ADDENDUM NO. 2

DATE: April 24, 2026
PROJECT: Ouachita Water Treatment Plant Sedimentation Basins 1-5
Plate Setter Project
Hot Springs, Arkansas

HOT SPRINGS, ARKANSAS		JOB NO.
OUACHITA WATER TREATMENT PLANT		25015
SEDIMENTATION BASINS 1-5 PLATE SETTLER PROJECT		SHEET NO.
REGULATORY REVIEW		C2
PROPOSED EQUIPMENT SECTIONS - 1

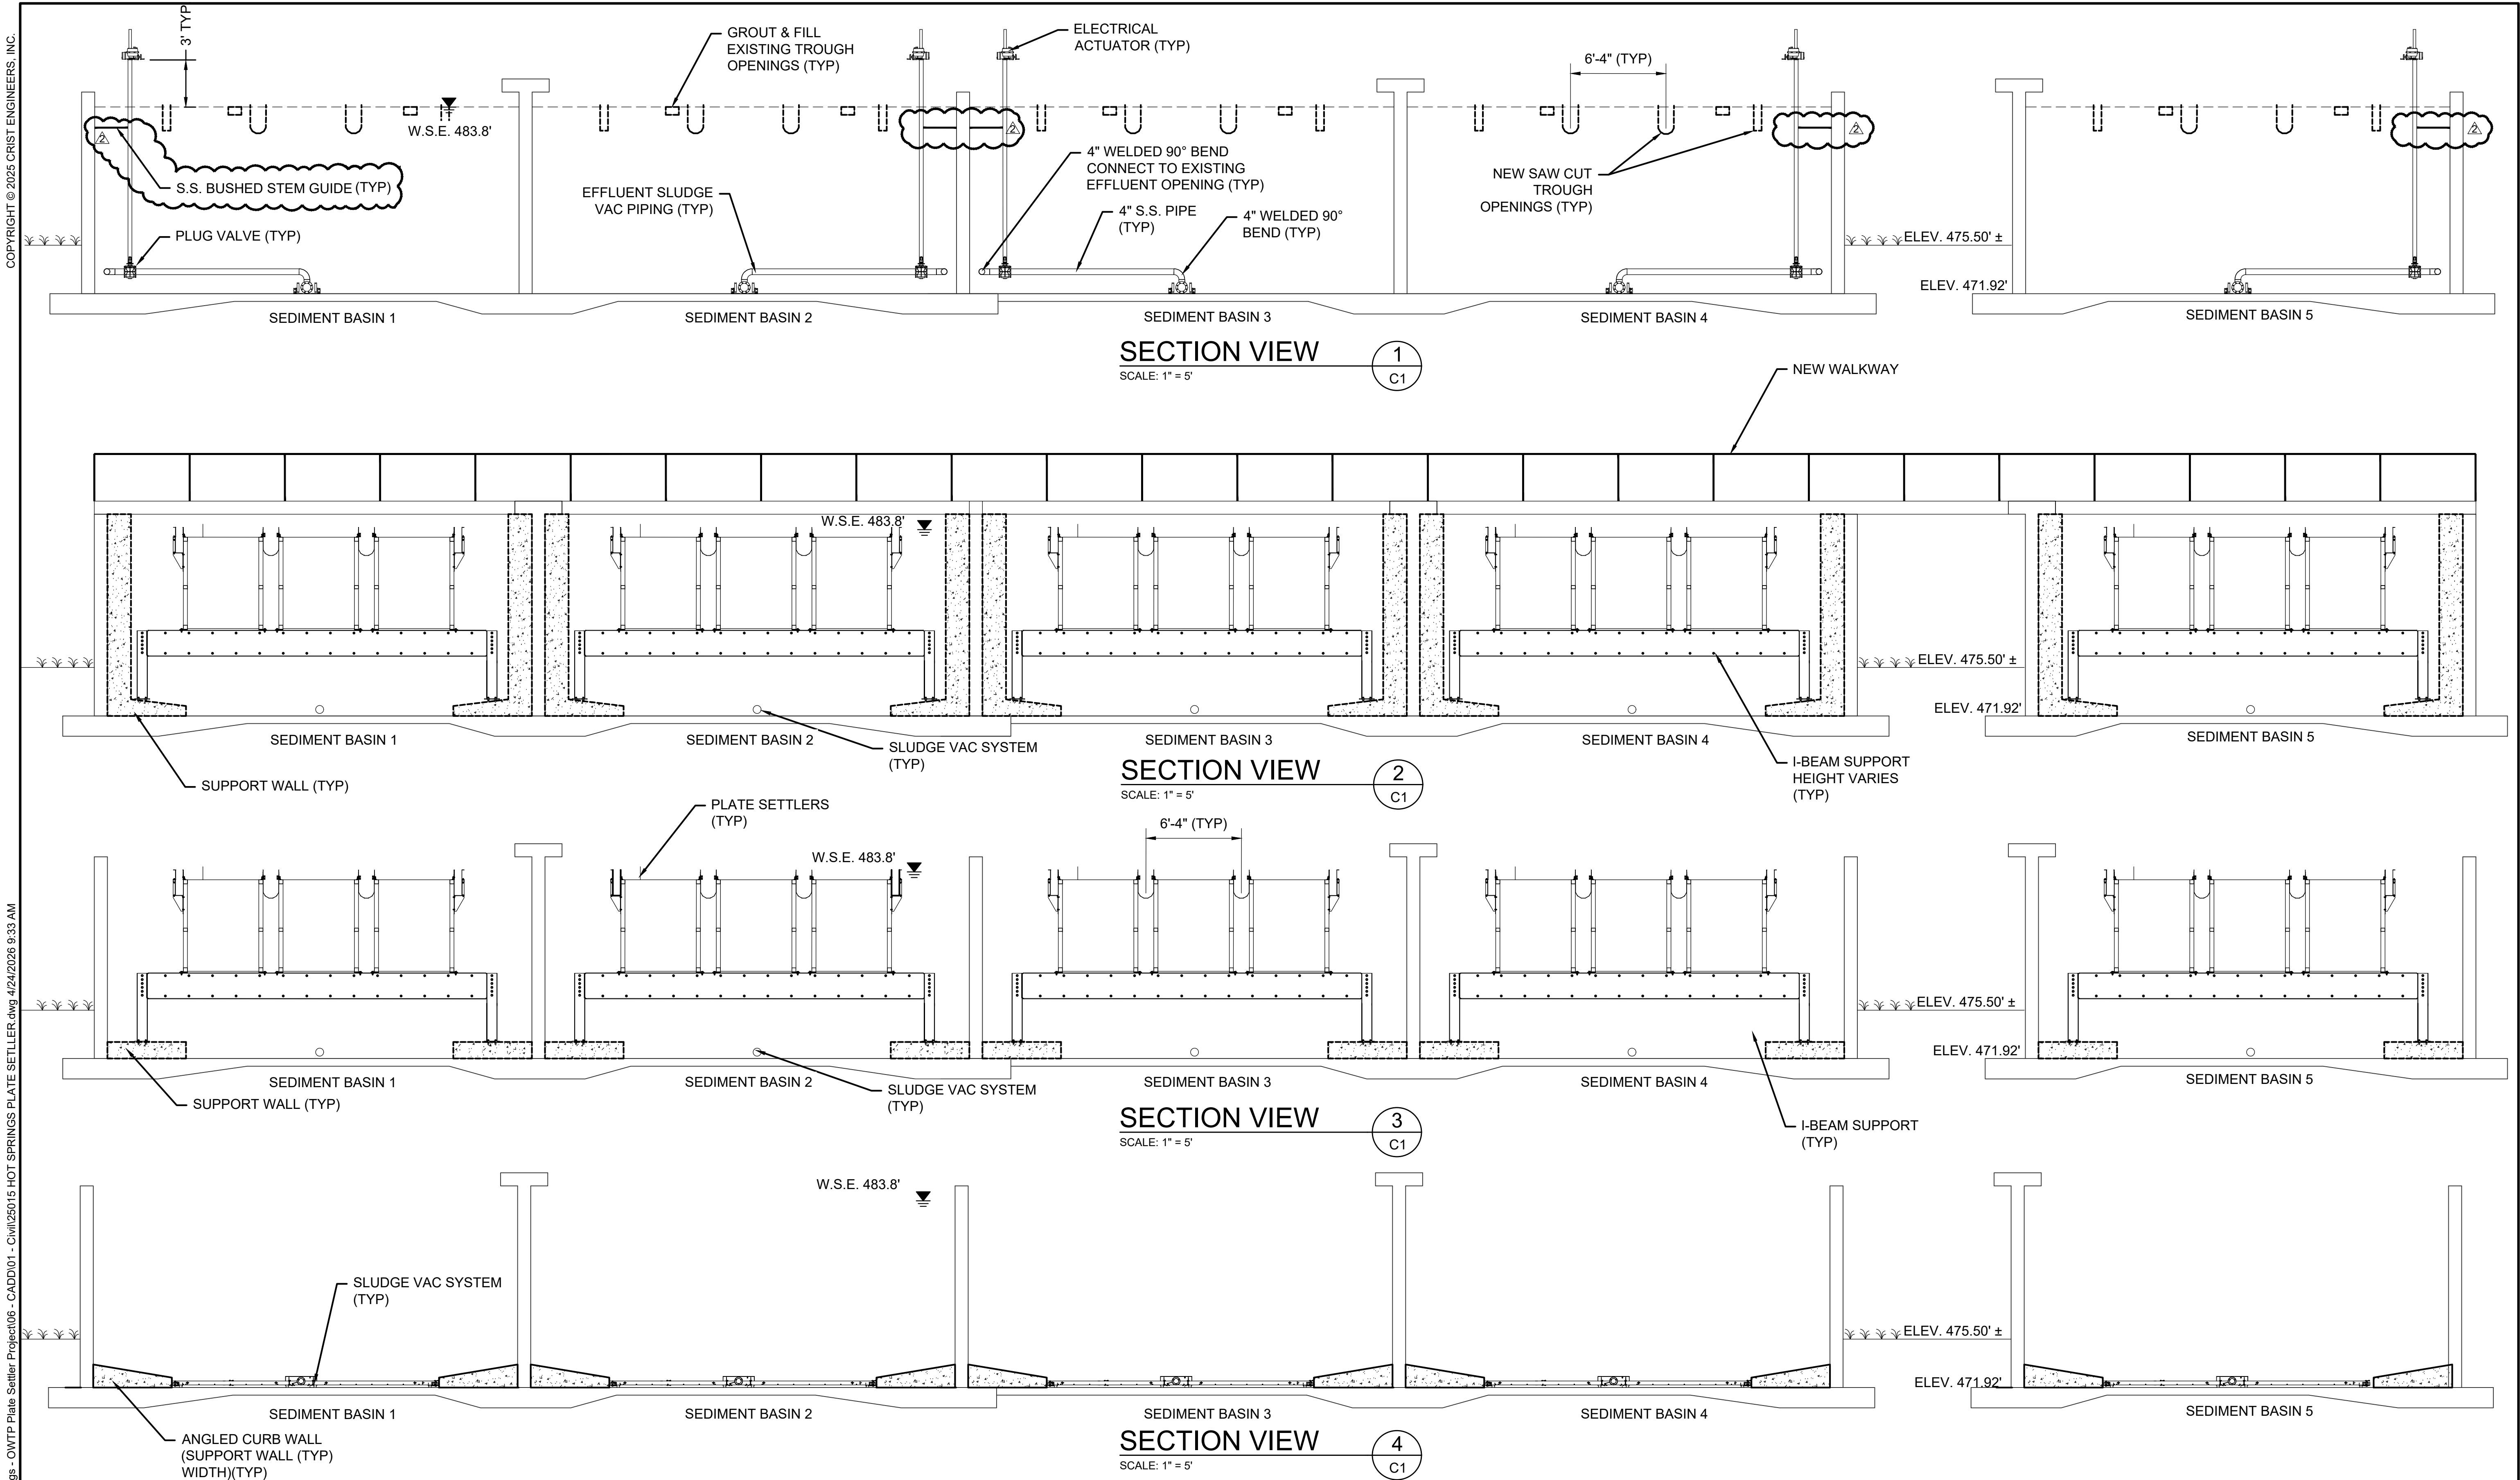
Item No. 16. Construction Drawings – Sheet C2 Proposed Equipment Section -1

REV. NO.	DATE	DRWN	CHKD	REMARKS
1	4/24/26	ATV	MU	INCLUDED ACTUATOR VALVE STEM GUIDE.
